# Recall Bulletin

## PRODUCT SAFETY RECALL

**SUBJECT:** Electric Power Steering Assist

The Caution statement in the service procedure has been revised. Please discard all copies of bulletin 14115A.

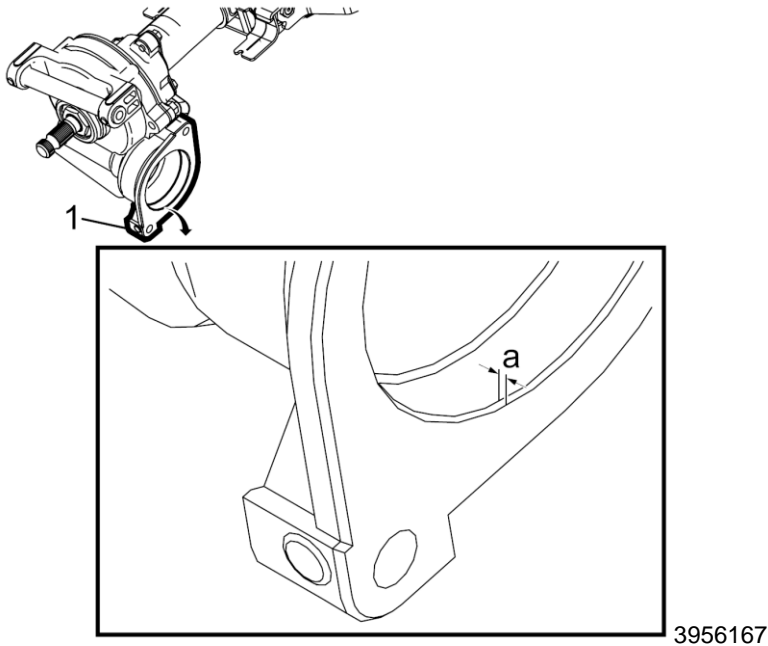
**Caution:** Do not install a seal on a "first design" steering motor. Installing a seal on a "first design" steering motor may damage the steering motor which may result in loss of assist steering. A seal is only required on a "second design" steering motor – the motor with the larger chamfer.

Before installing the power steering assist motor, inspect the power steering assist motor housing (1) to verify the steering column design:

- **First Design:** If the chamfer (a) is **1 mm (0.04 in)** and **30 degrees** then the steering column is the first design and a power steering assist motor O-ring seal is NOT needed.
- **Second Design:** If the chamfer (a) is **2.7 mm (0.11 in)** and **45 degrees** then the steering column is the second design and a NEW power steering assist motor O-ring seal IS needed.
